UNITED STATES
DEPARTMENT OF THE INTERIOR
BUREAU OF LAND MANAGEMENT

8. Well Name and No.
Central Bisti Unit No. WI 4

Re: Permanent Abandonment

CONDITIONS OF APPROVAL

Central Bisti Unit No. 4WI

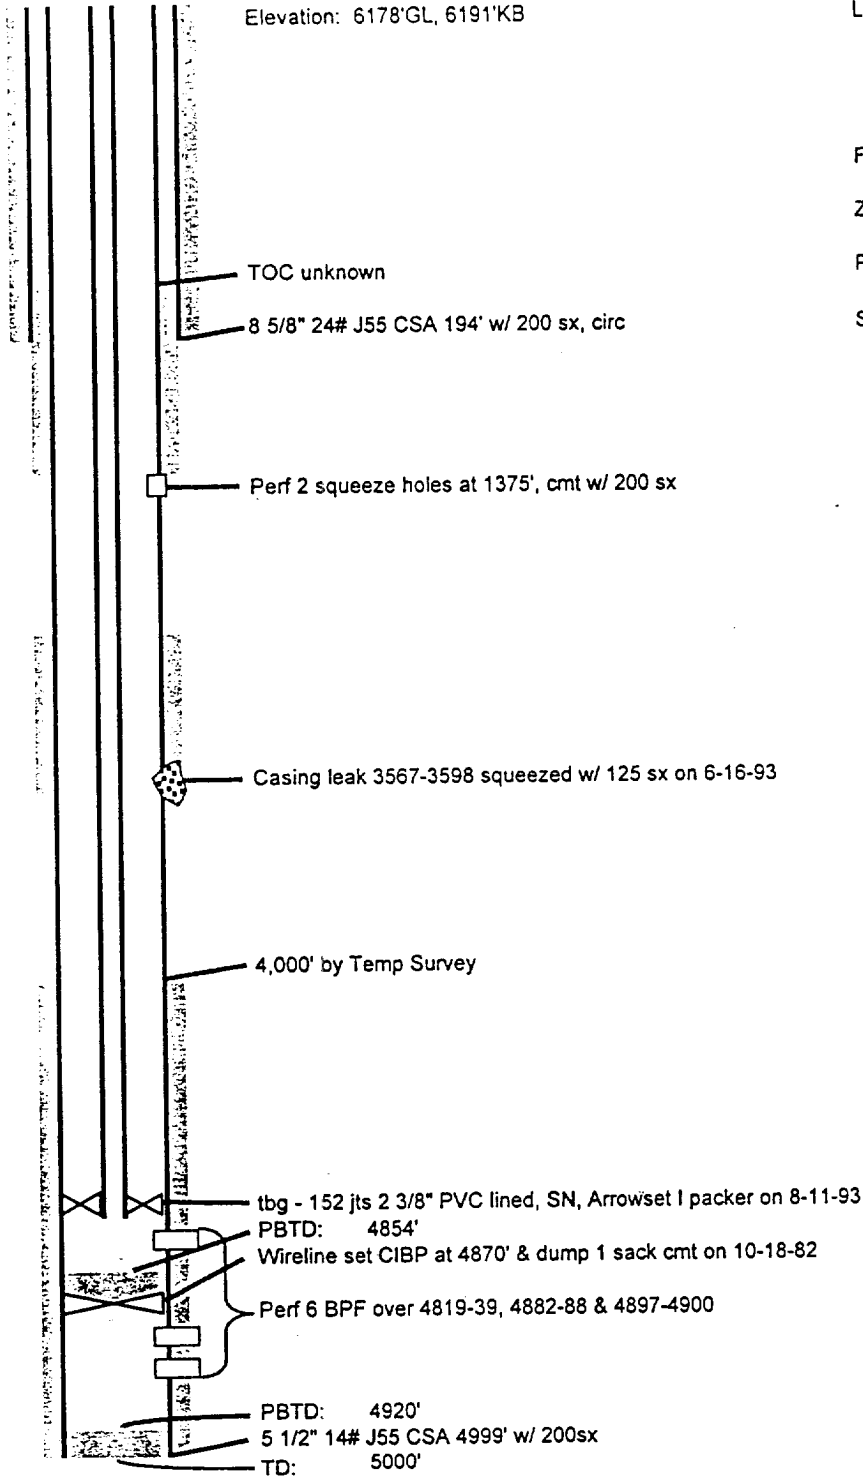
3. The following modifications to your plugging program are to be made:

- a) Place the Mesaverde plug from 1951' - 1851' inside and outside the 5 ½" casing.
- b) Place the Pictured Cliffs plug from 1243' - 1143' inside and outside the 5 ½" casing.
- c) Place the Fruitland plug from 920' - 820' inside and outside the 5 ½" casing.
- d) Combine the surface casing shoe plug and the surface plug from 244' to surface to cover the Ojo Alamo.

You are also required to place cement excesses per 4.4 of the attached General Requirements. Note: Cement was reported placed from 1375', which calculates to a top of near surface. Squeezing cement behind the 5 ½" casing may not be possible from the Pictured Cliffs to surface.
